Accessibility Survey

City of Downey Chavers Avenue - Hondo Street To Rundell Street

Date of Inspection
4/12/2017

Prepared By
Disability Access Consultants
(800) 743-7067

Change In Level South Of Rundell Street @ 33.931656051612, -118.155762255192

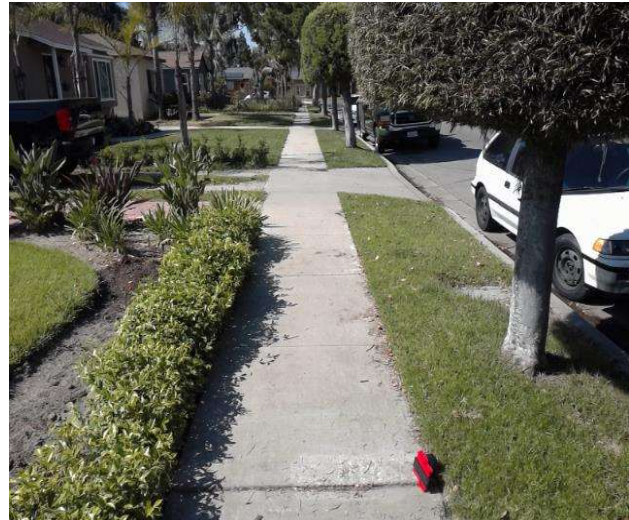
There is a change in elevation greater than recommended value.

On-Site Finding 0.50 inches

Ensure that the change in elevation is within the recommended value.

Recommendation Up to 0.25 inches

Sidewalk South Of Rundell Street @ 33.931767323517, -118.155668377876

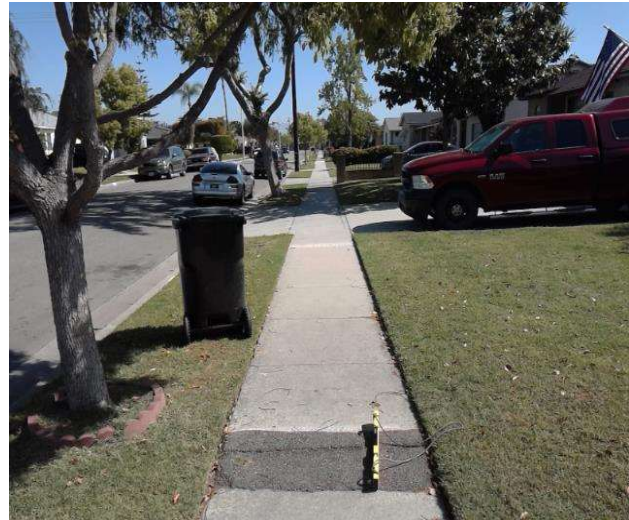
Sidewalk running slope is not compliant.

On-Site Finding 9.40 percent for 2.00 feet

Notes : Surface is rough and uneven.

Repave the sidewalk surface with the recommended running slope.

Recommendation Up to 5.00 percent

Change In Level North Of Hondo Street @ 33.932051066217, -118.155638873577

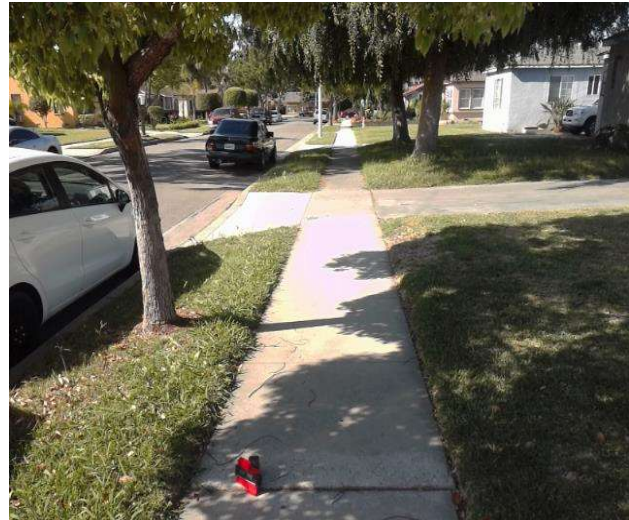
There is a change in elevation greater than recommended value.

On-Site Finding 0.87 inches

Ensure that the change in elevation is within the recommended value.

Recommendation Up to 0.25 inches

Sidewalk North Of Hondo Street @ 33.931865242674, -118.155781030655

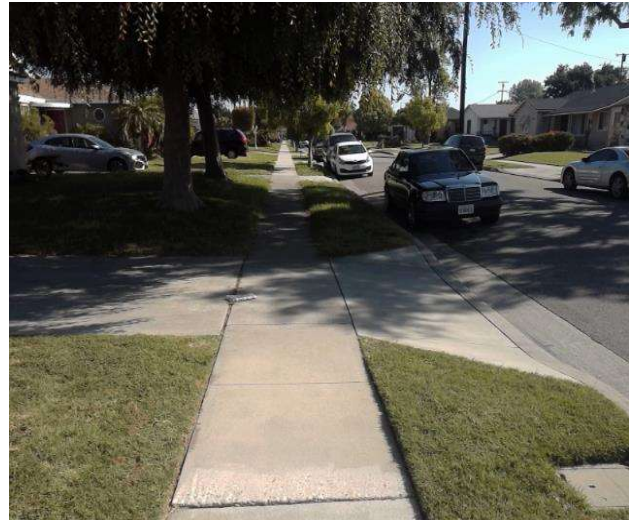
Sidewalk cross slope is not compliant.

On-Site Finding 5.00 percent for 210.00 feet

Repave the sidewalk surface with the recommended cross slope.

Recommendation Up to 2.08 percent

Tree North Of Hondo Street @ 33.931433507366, -118.156114965677

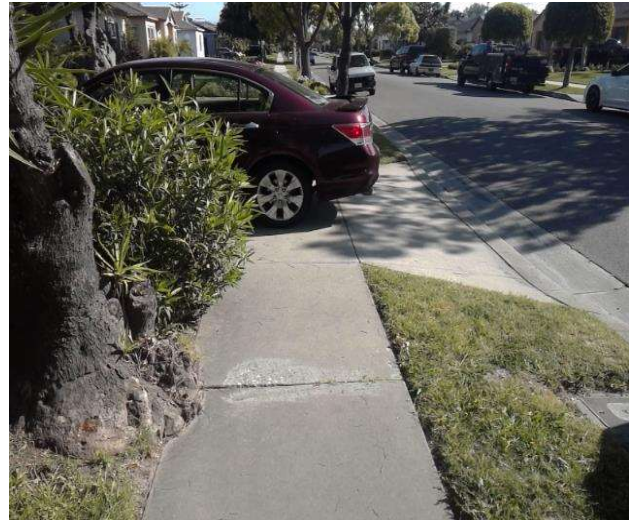
Sidewalk width at the obstruction is not compliant.

On-Site Finding 42.00 inches

Sidewalk width at the obstruction shall have the recommended value.

Recommendation At least 48.00 inches
